**COUNTY OF WESTCHESTER
NEW YORK
DIVISION OF ENGINEERING**

**ADDENDUM NO. 3
CONTRACT NO. 20-530**

**Infrastructure Rehabilitation – Phase 2
Playland Park
Rye, New York**

AD-COL-S-02

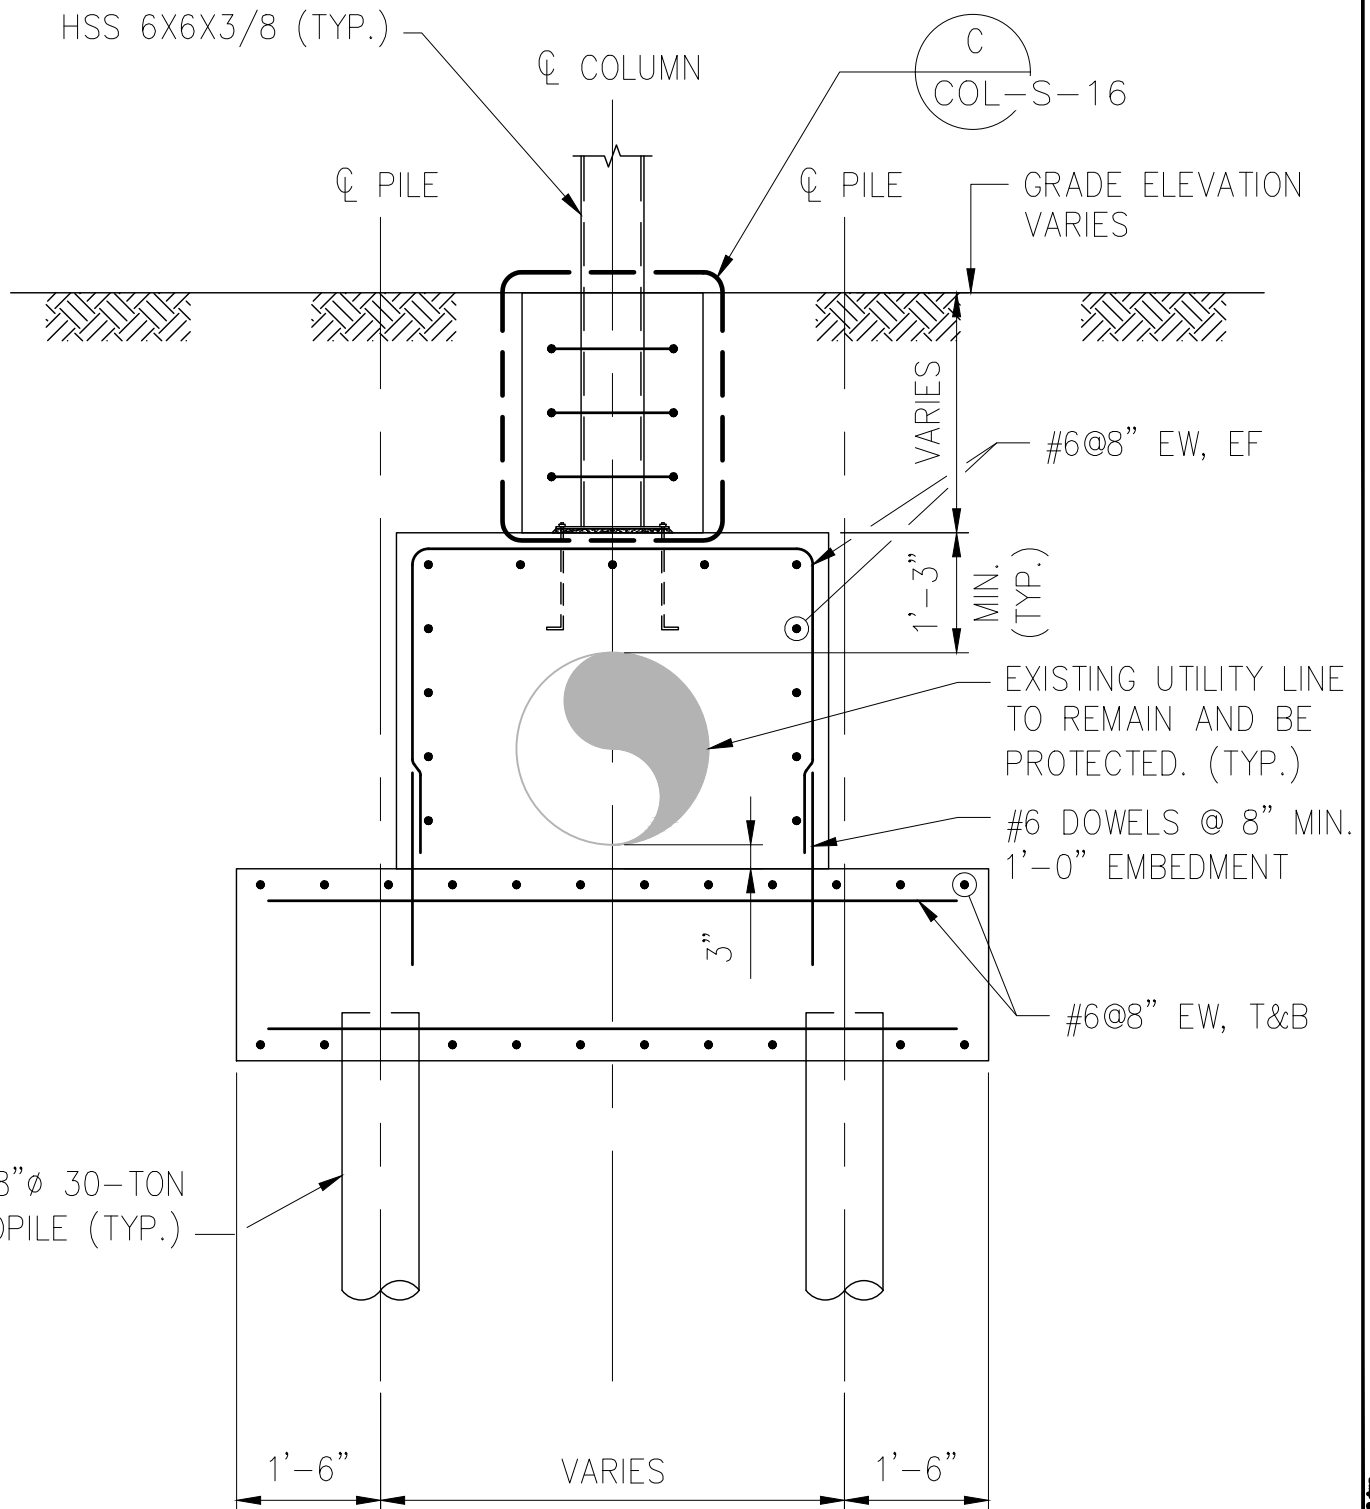
Item 16: Drawing COL-S-19, *Colonnade Reconstruction Details*.
Insert detail as shown on Addendum Drawing AD-COL-S-02.
